D, D_c, V value trade-off formula (Mr. Svensson)

Consideration around the V value calculation formula and some
Central Axle Trailer applications

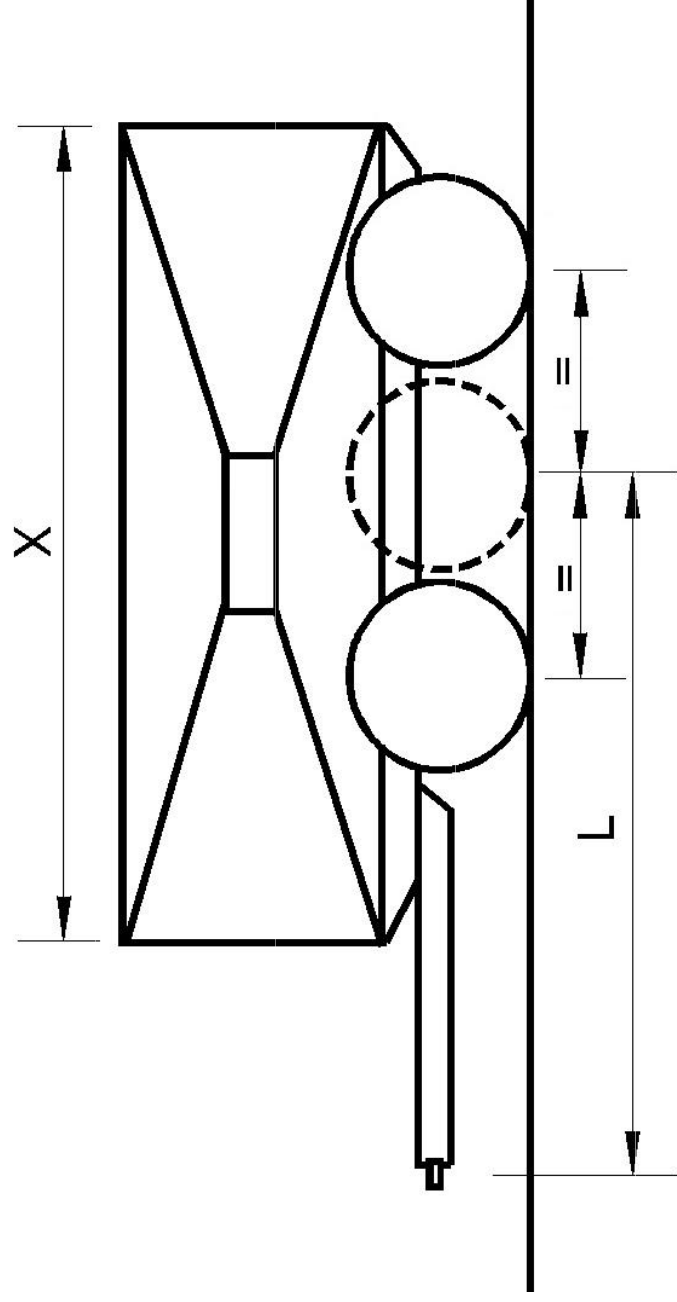
**In some applications the approximation to a single central axle in the V value calculation formula is too restrictive.
Below is a picture of a formally “Central Axle Trailer” with 2 or 3 axles.
The distance between the extreme axles can reach 2800 mm.**

Application of actual V value formula to the described application it too severe.

A 3 axles CAT as pictures with 32 t mass calculated with actual formula Can gives as result a **V value up to 150 kN.**

The proposal is to add into the calculation formula a **linear dependence with the axles distance** (and the position of the center of gravity of the trailer).
